Flex Fuel Extended Crank due to Alcohol Density Calculation

Service
Category Engine/Hybrid System

Section Engine Control

YEAR(S)	MODEL(S)	ADDITIONAL INFORMATION
2012 – 2013	Sequoia	
2012 – 2013	Tundra

Figure 1. Location of Authorized Modifications Label on 2012 – 2013 Sequoia and Tundra

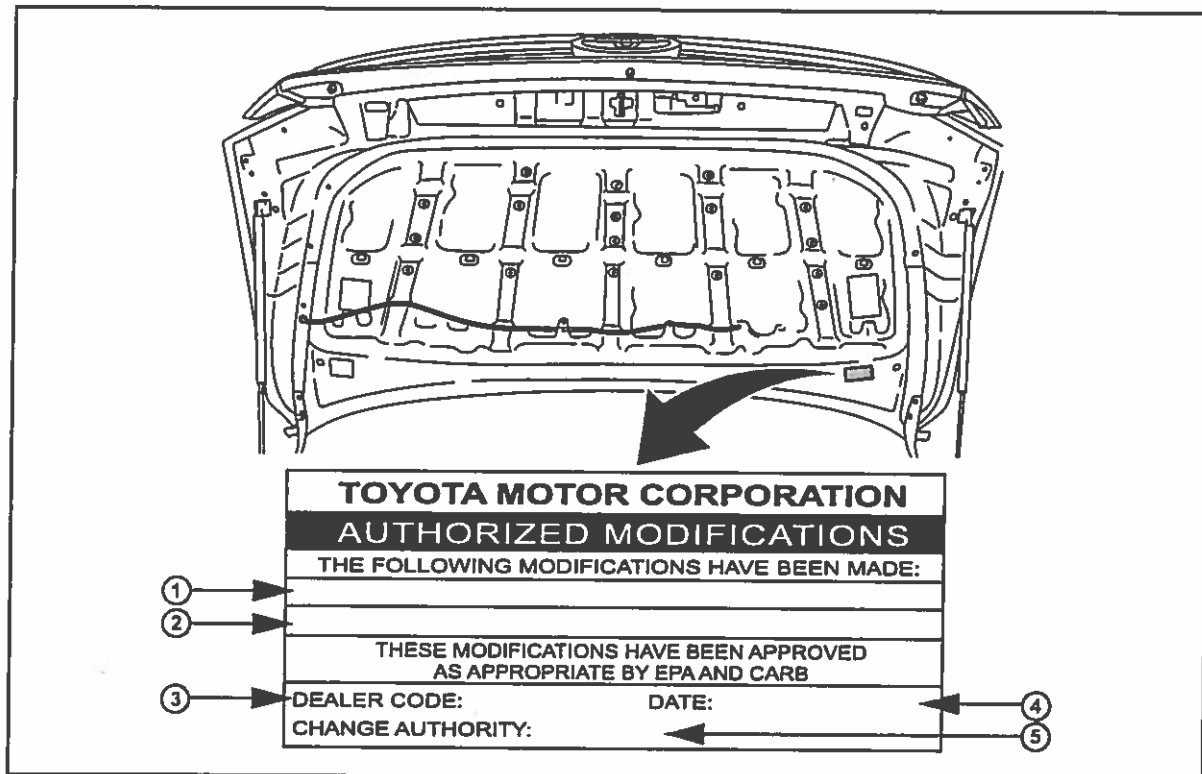
4. Check for the Authorized Modifications Label affixed to the vehicle in the location shown in Figure 1. Confirm if the ECM (PCM) calibration has been updated. If the calibration ID listed is NOT the latest ECM (PCM) calibration — go to step 5.

B. Affix the Authorized Modifications Label to the vehicle at the location shown in Figure 1. The Authorized Modifications Label is available through the MDC, P/N 00451-00001-LBL.

A. Using a permanent marker, enter the following information on the label:

- ECM part number [Refer to the *Parts Information* section for the **CURRENT PART NUMBER**]
- Calibration ID(s) [Refer to the *Calibration Identification Chart* for the **NEW CALIBRATION ID**]
- Dealer Code
- Repair Date
- Change Authority [*This SB number*]
